SUBJECT:
RESPONSE TO QUESTIONS CONCERNING APPLICANT'S OVERPRESSURE SUBMITTALS OF OCT
31, DEC 15, AND DEC 22, 1977, AS REQUESTED BY NRC'S JAN 06 & 10, 1978
TELECON. . . NOTARIZED 01/25/78. . . W/ATT SUPPORTING DRAWINGS.

PLANT NAME: H B ROBINSON - UNIT 2

H. B. ROBINSON STEAM ELECTRIC PLANT, UNIT NO. 2
DOCKET NO. 50-261
LICENSE NO. DPR-23
REACTOR VESSEL OVERPRESSURE PROTECTION
REQUEST FOR LICENSE AMENDMENT

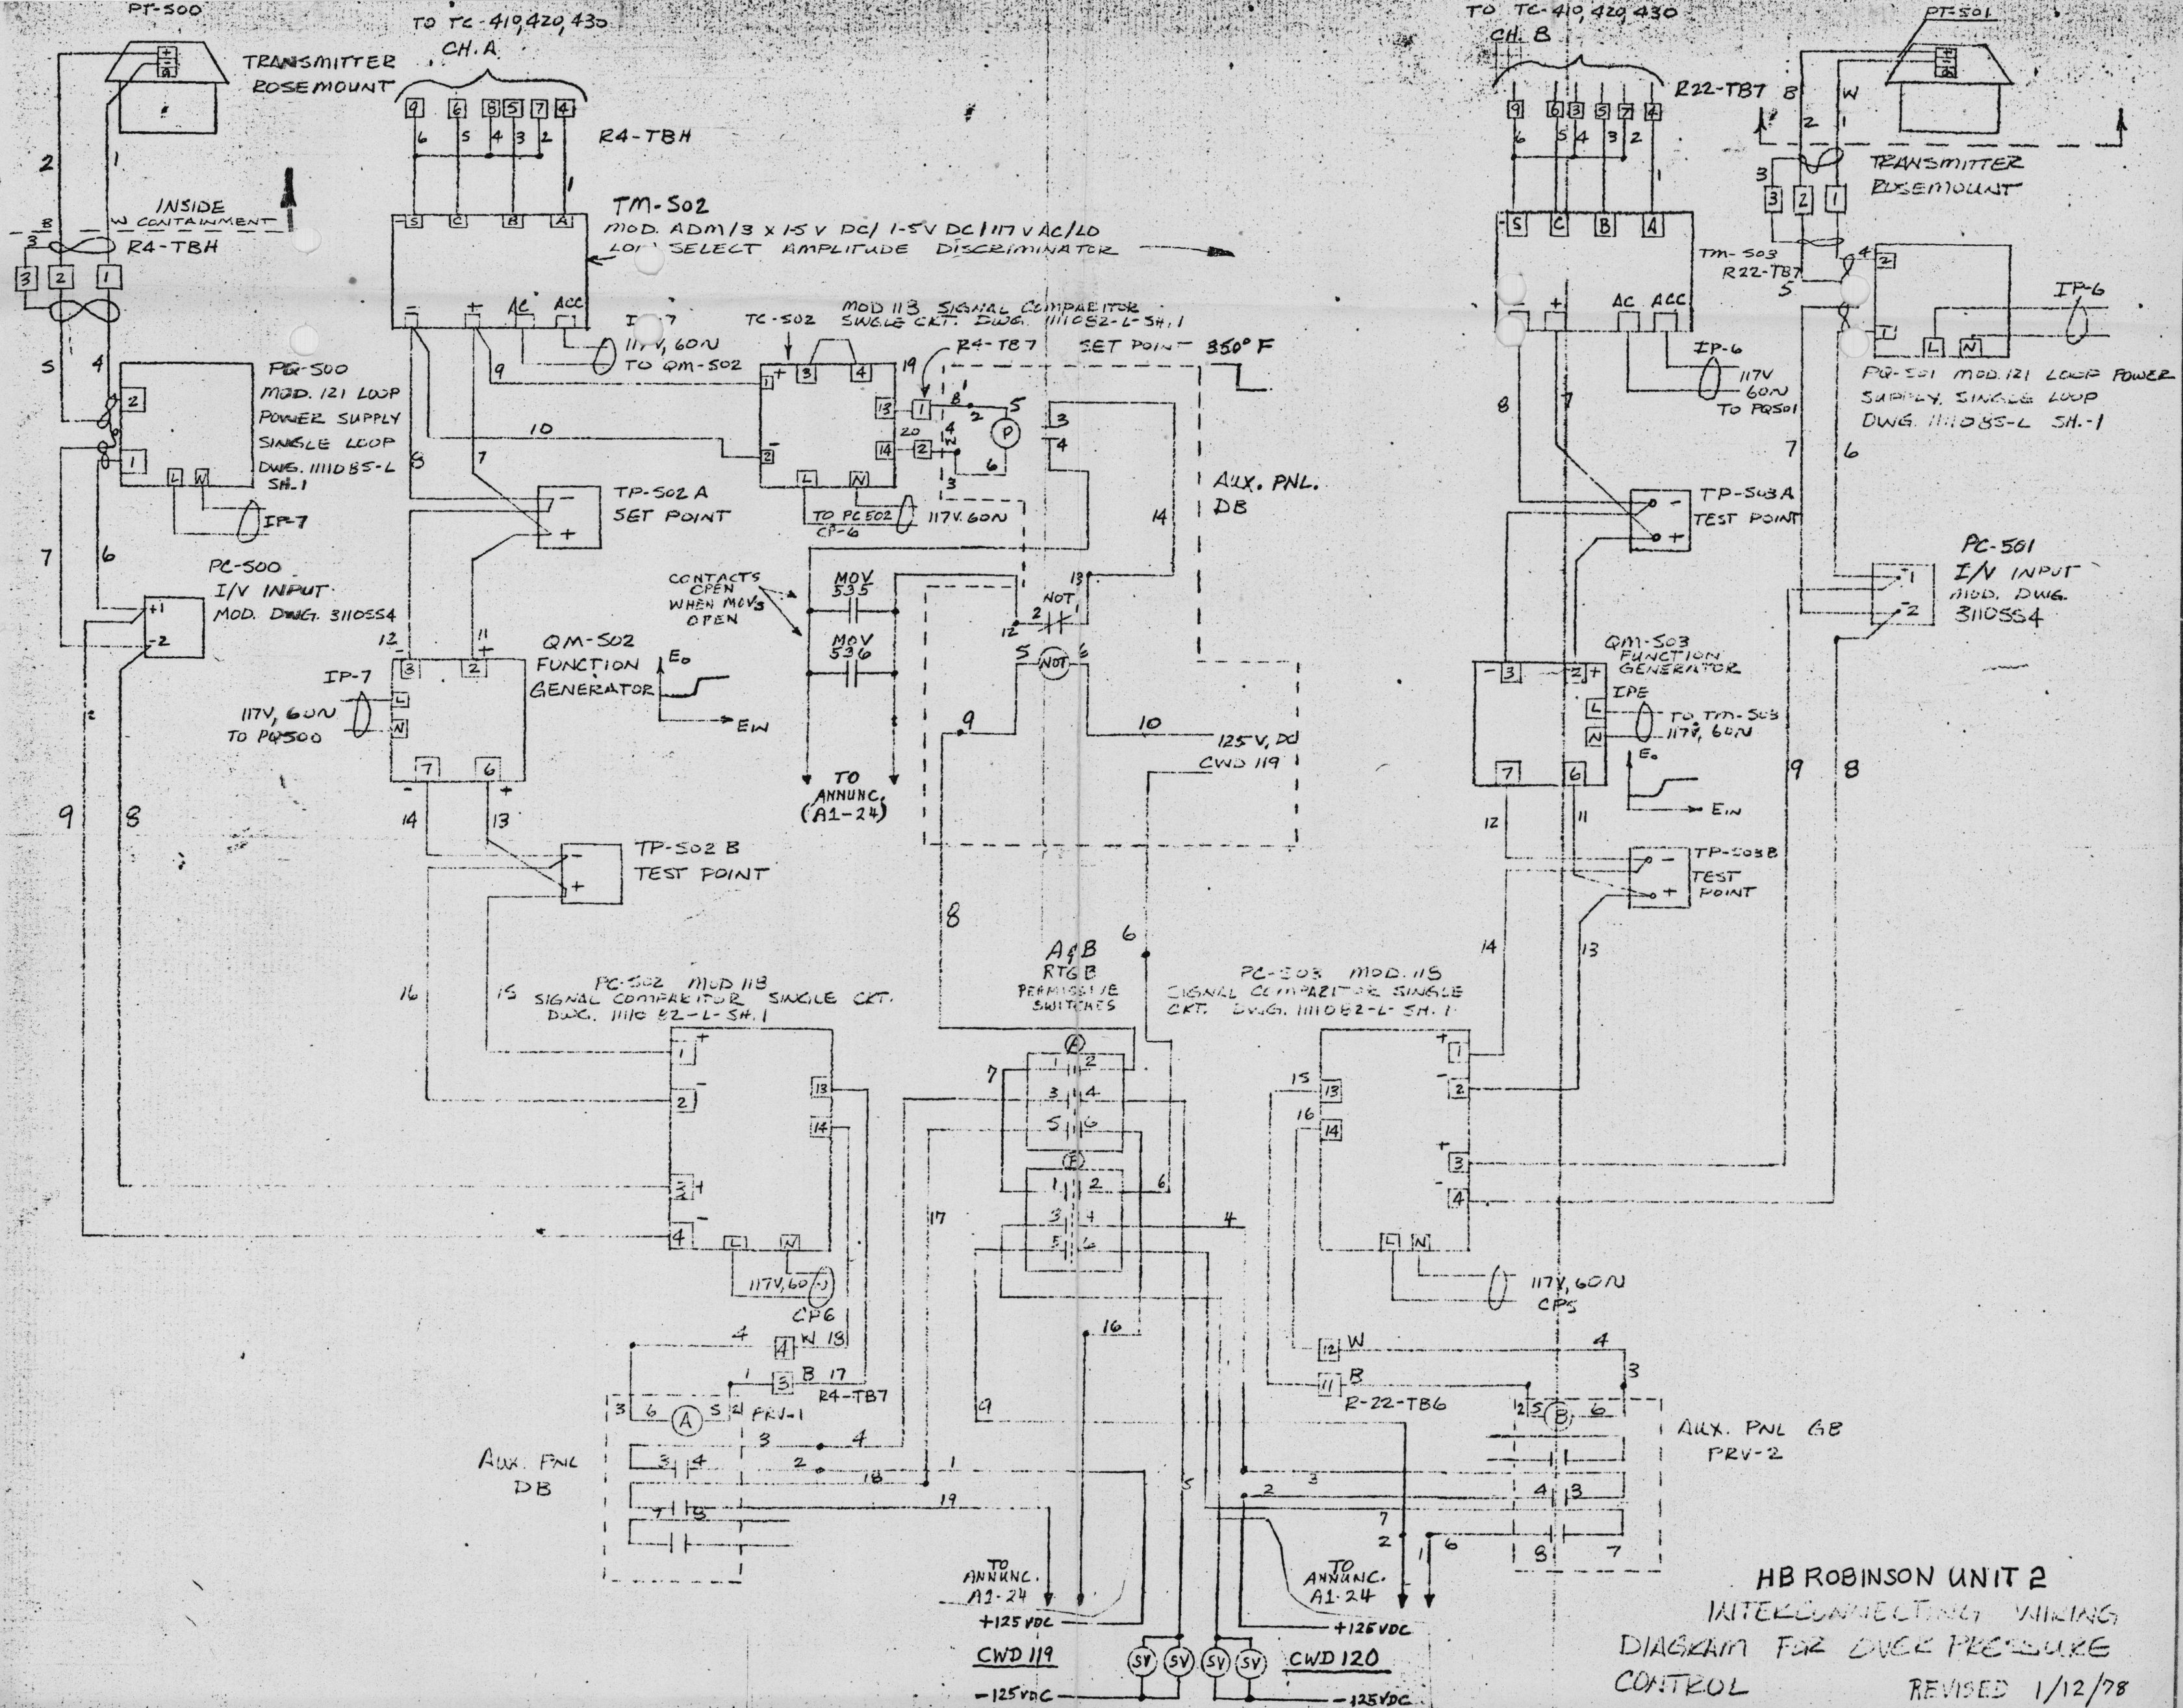
2. As discussed, a revised version of the wiring diagram of the system is attached. Also attached is a revised schematic of the nitrogen system with a corrected solenoid arrangement and all pressure indicators outside of the pressurizer cubicle.

LOGIC DIAGRAM FOR
OVERPRESSURE PROTECTION
H.B. ROBINSON SEG PLANT, UNIT 2
BY: F. BISHOP 10-14-77
SHEET 1 OF 2 REVISED: 1-13-78

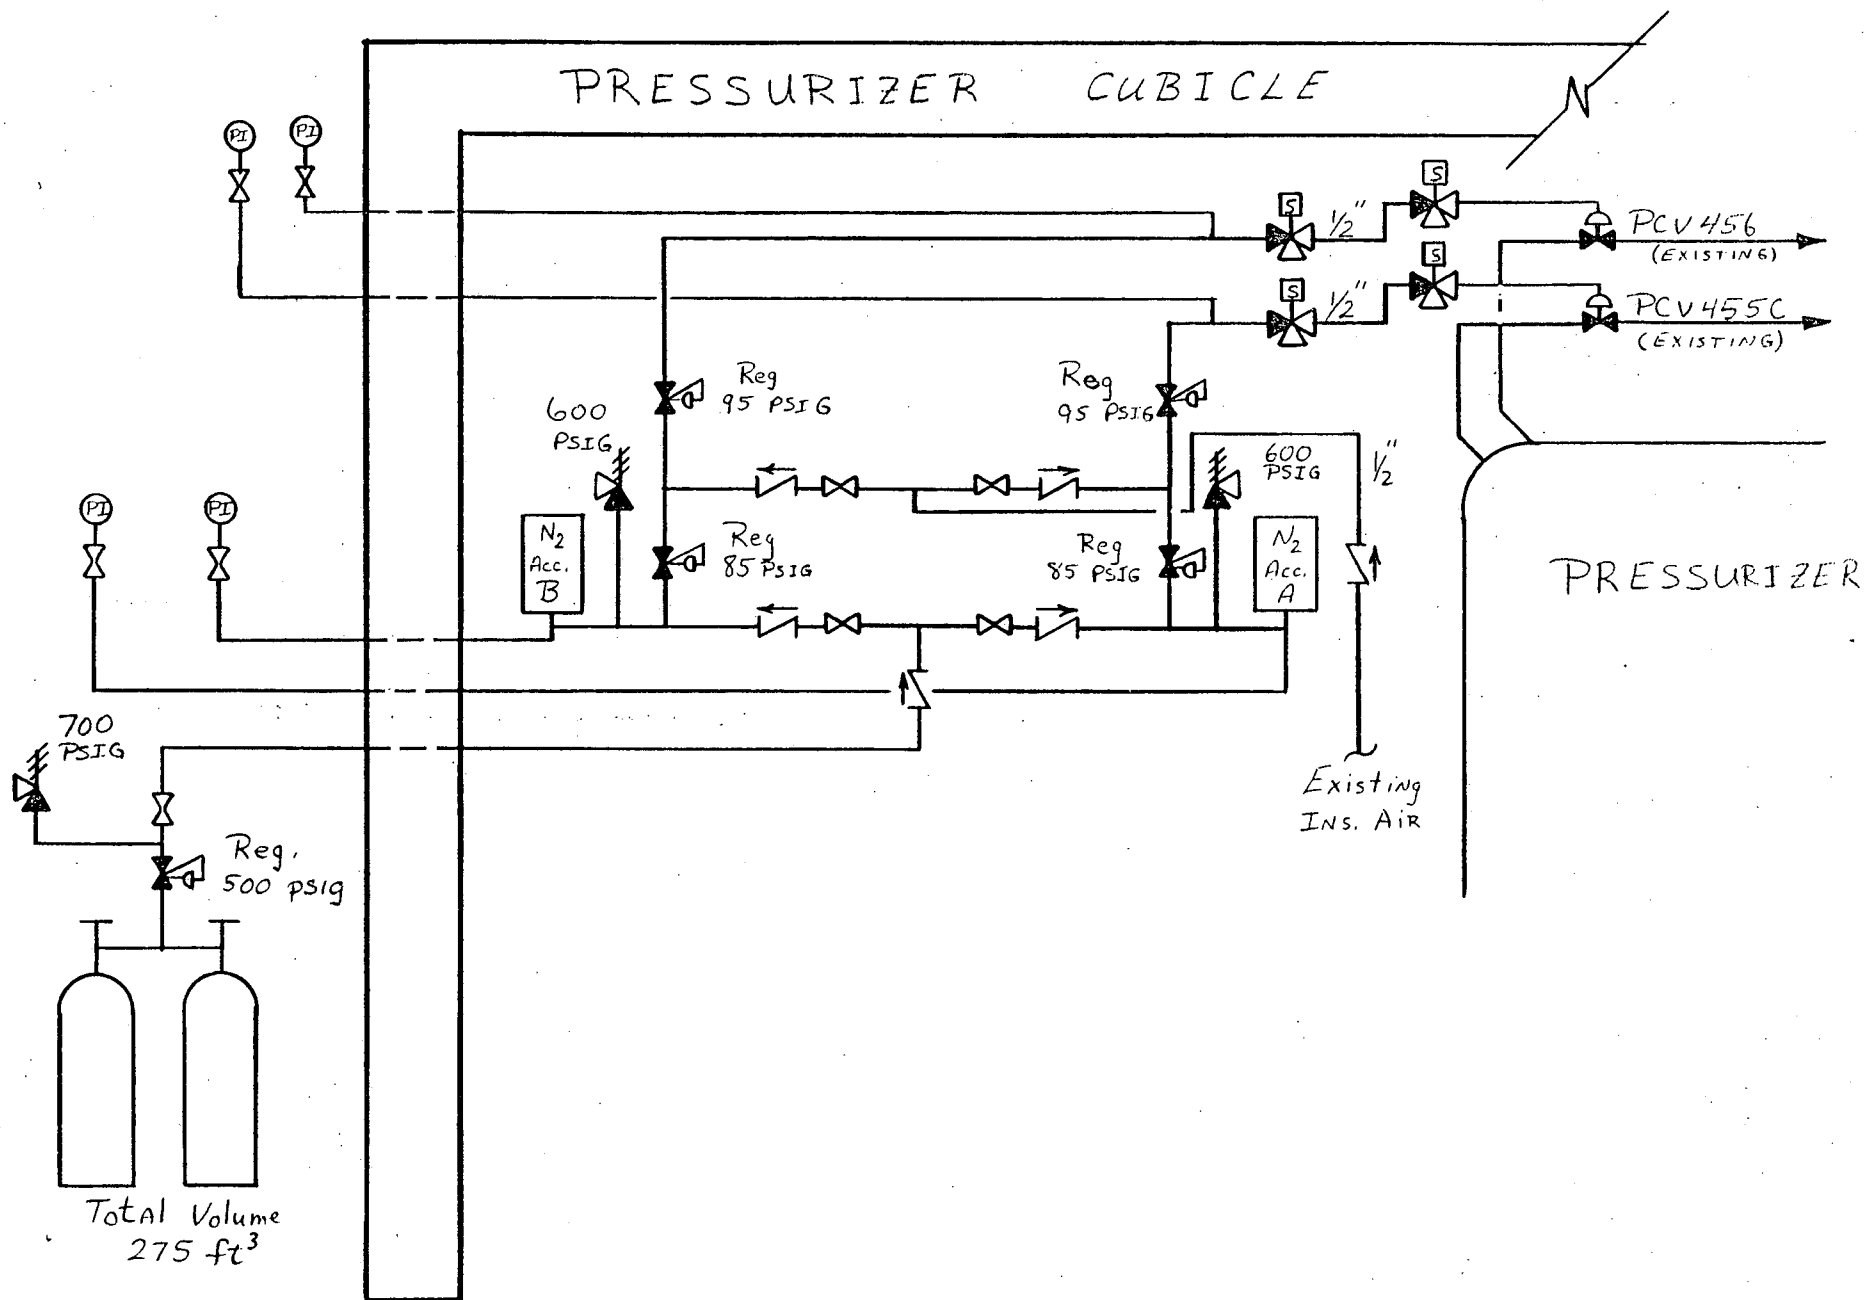
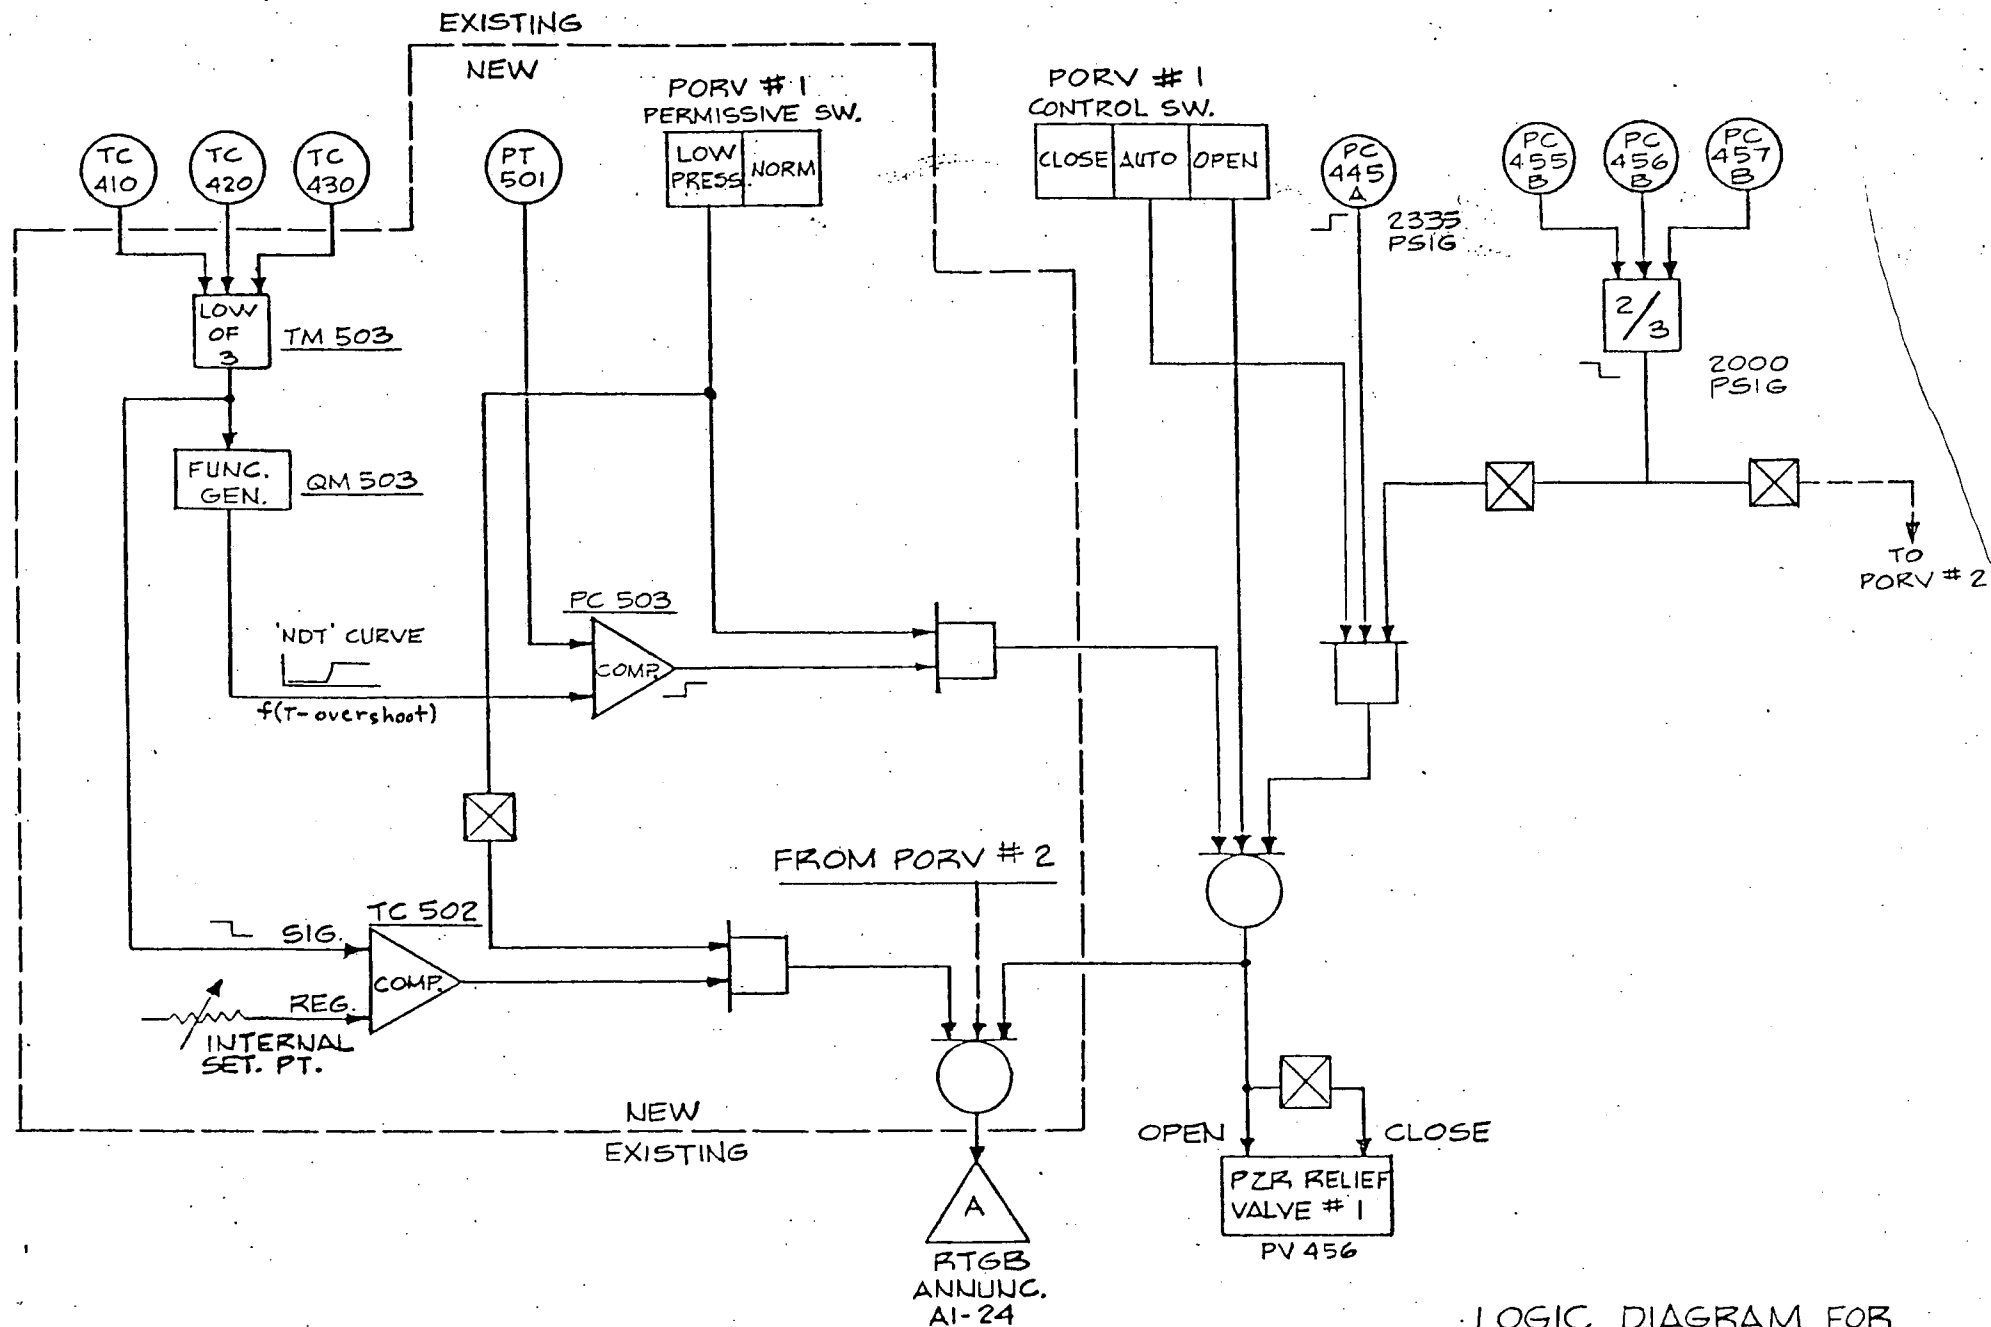
3. The entire modification has been reviewed with respect to compliance with IEEE-279 and some changes have been made to bring the proposed modification into compliance. Because of uncertainties in the interpretation of the separation criteria, the logic has been changed as reflected in this submittal. In the revised system each valve will be associated with its own logic train and will not receive signals from the other train.
